Dear reviewer,

Your comments were highly helpful. We really appreciate your attention and comments on our manuscript. Our replies are listed as follows:

Fig1. Schematic diagram of CSEM

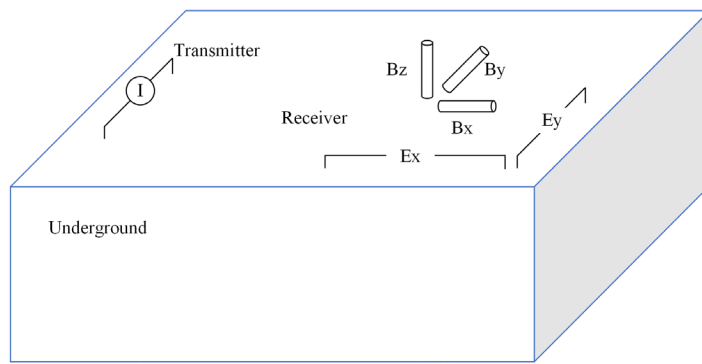
*Comments 1.* Figure1: It appears that the Bx, By, Bz part of the figure is based on a left-handed coordinate system. Please check that this figure visually presents as intended.

*Response 1:* We appreciate you raising this point. We have modified Figure 1, changing Bx, By, and Bz to be based on the right-hand coordinate system. The modified image is shown below:

Fig3. Internal circuit of electrodes in electric field sensors

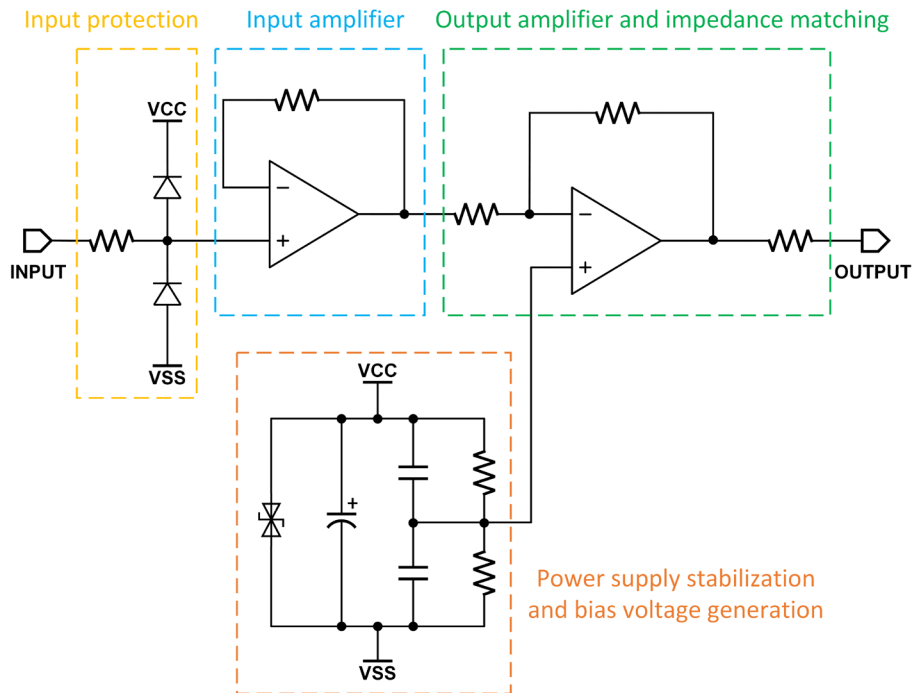
*Comments 2.* Line 80: The analog board is connected to both electric and magnetic field sensors. Please elaborate on the sensors and the necessary electrical protection and signal conditioning of the instrument.

*Response 2:* Thank you so much for your comment. The electric field sensor uses an active transmission line with a front-end amplifier, connected to a metal rod buried in the soil. The magnetic field sensor uses an inductive magnetic sensor. The input circuit for the signal is protected by Schottky diodes and current-limiting resistors. We have revised the corresponding section of the article. We have also pasted the modified paragraph below:

“As shown in Figure 3, the electric field sensor uses an active transmission line with a front-end amplifier, connected to a metal rod buried in the soil. The magnetic field sensor uses an inductive magnetic sensor. The input circuit for the signal is protected by Schottky diodes and current-limiting resistors as shown in Figure 4.

Fig12. Measured value of short-circuit noise

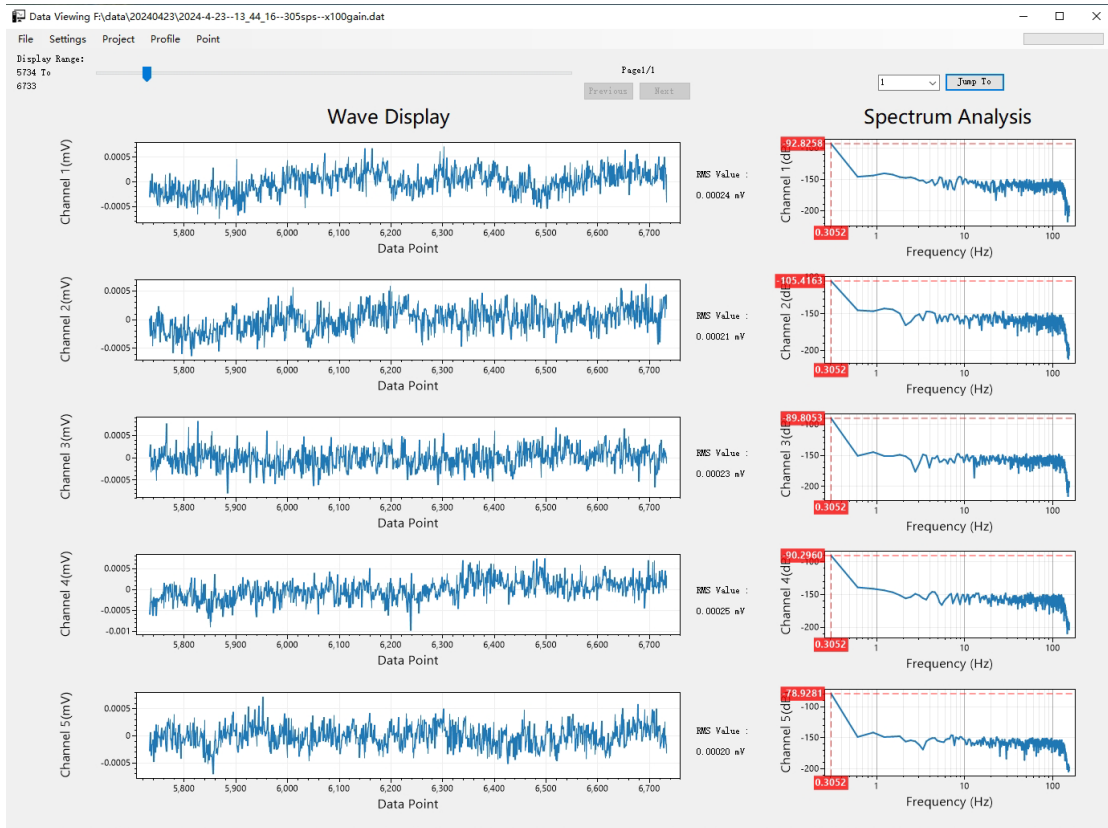
*Comments 7.* Line 185, Figure 11/12. It would be appropriate to augment both figures with a frequency analysis of the recorded data to show the spectral purity of the sine waves (Figure 11) as well as the shape of the noise floor of the instrument (Figure 12).

Response 7: We are grateful for your suggestion. We have added the signal's spectrum analysis chart. The added image is shown below:

Fig18. Electric field and magnetic field power spectral density

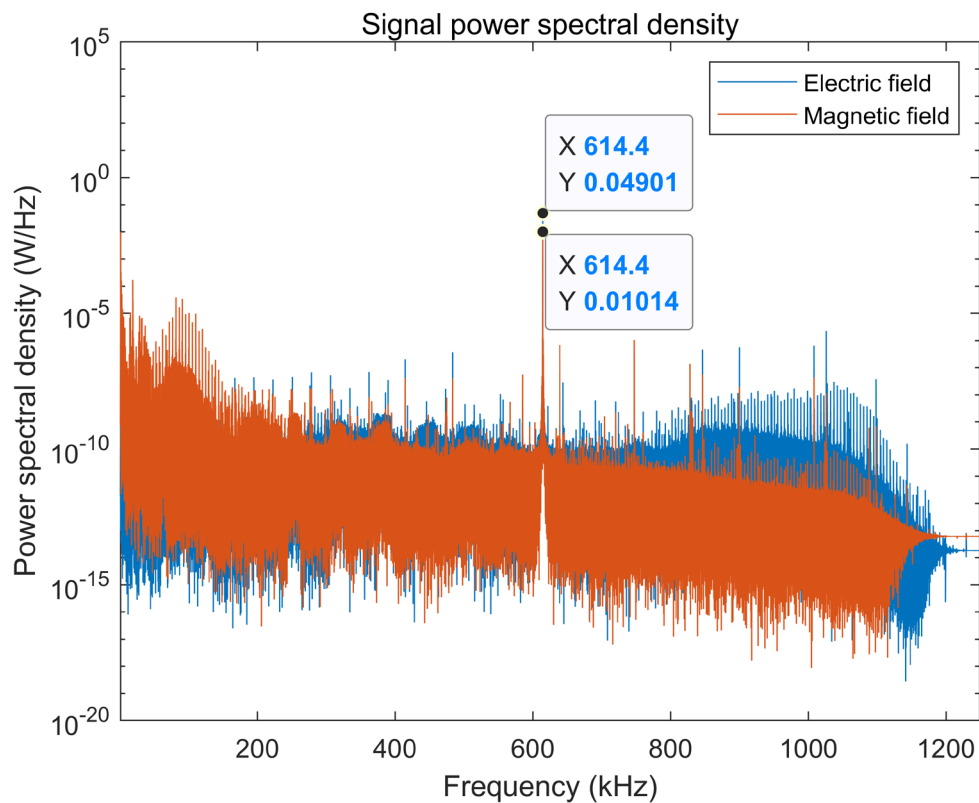
*Comments 9.* Line 192, Figure 15/16. These figures can be merged into one figure, and they should be plotted with a logarithmic y-axis. This choice of axis formatting will make the noise floor visible, and the performance of the instrument can be much better assessed. It would also be appropriate to show actual data and discuss the quality of these.

*Response 9:* Your suggestion is highly valued. We have modified the figure, which is shown below:
